Access Compliance Report

Public Rights-of-Way

Intersection ID: 15639	Main Street: EASTOVER_RD	Cross Street: HEMPSTEAD_PL	Location: SW
ADA ID: 424E5EE21B0B	Ramp Type: PerpDiag	Initial Pass/Fail: Pass	Overall Compliance: No
			Severity Score: 10.25

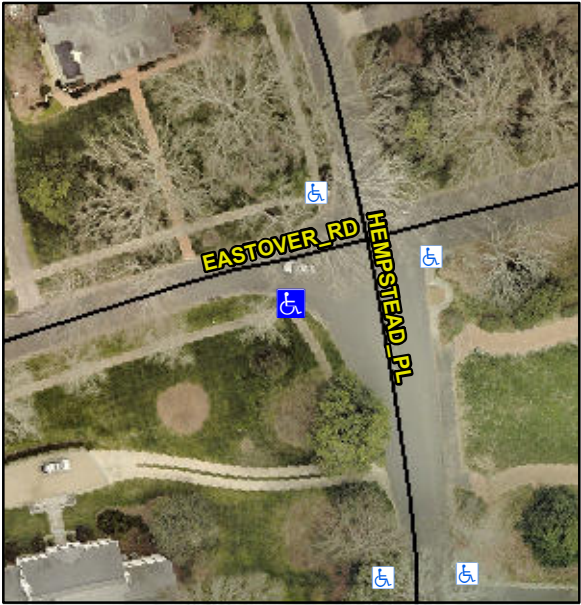
Codes/Mitigation Info/Possible Solution		Field Measurements/Component Compliance			
	Possible Solutions:				
	Remove & Replace Curb Ramp With Two New Directional Ramps or Equivalent. Remove & Replace Gutter.				
	Surveyor Notes:				
	N/A				
	PROW/ADA:				
	Not Found, R304.5.3, R304.2.1, R304.2.2-Perp, R304.3.2-Para				
Street 1 Name	HEMPSTEAD PL				
Stop Condition-Street 2	None				
Street 2 Name	EASTOVER RD				
Stop Condition-Street 1	StopSign				
Total Cost:		\$	3950.00

Compliance	Description	Data	Compliance	Description	Data
N/A	Ramp Length (in)	80.0	Yes	Ramp Slope (%)	5.8
Yes	Ramp Width (in)	48.0	No	Ramp XSlope (%)	3.0
N/A	Flare Type LT	Sloped	N/A	Flare Type RT	N/A
N/A	Flare Slope LT (%)	4.1	Yes	Flare Slope RT (%)	9.0
N/A	Flare Traversable LT?	Yes	N/A	Flare Traversable RT?	Yes
No	Landing Length (in)	N/A	Yes	DWS Provided?	Yes
No	Landing Width (in)	N/A	Yes	DWS Contrast?	Yes
No	Landing Slope (%)	N/A	Yes	DWS Length (in)	25.5
No	Landing X Slope (%)	N/A	Yes	DWS Full Width?	Yes
N/A	Landing Curb? (Y/N)	No	Yes	DWS Offset (in)	2.0
N/A	Shared Landing?	N/A			
Yes	Gutter Ponding?	No	Yes	Gutter Slope (%)	0.9
Yes	Gutter Lip Ht (in)	0.0	No	Gutter X Slope (%)	2.3
N/A	Painted X Walk1?	No	N/A	Painted X Walk2?	No
	X Walk 1 Direction	To E		X Walk 2 Direction	To NE
N/A	X Walk 1 Width (in)	N/A	N/A	X Walk 2 Width (in)	N/A
	X Walk 1 Slope (%)	1.5		X Walk 2 Slope (%)	2.0
	X Walk 1 X Slope (%)	3.5		X Walk 2 X Slope (%)	0.8

N/A	Ramp inside XWalk1?	N/A	N/A	Ramp inside XWalk2?	N/A
	Road Slope (%)	3.3	N/A	Clear Space?	Yes
	Road X Slope (%)	3.7	N/A	Clear Space to XWalk (in)	N/A
Yes	Any Obstructions?	No	Yes	Storm Grate/Utility Hazard?	No
	Obstruction Type			Storm Grate/Utility Type	
		N/A			N/A
			Yes	Surface Condition? (G/P)	Good
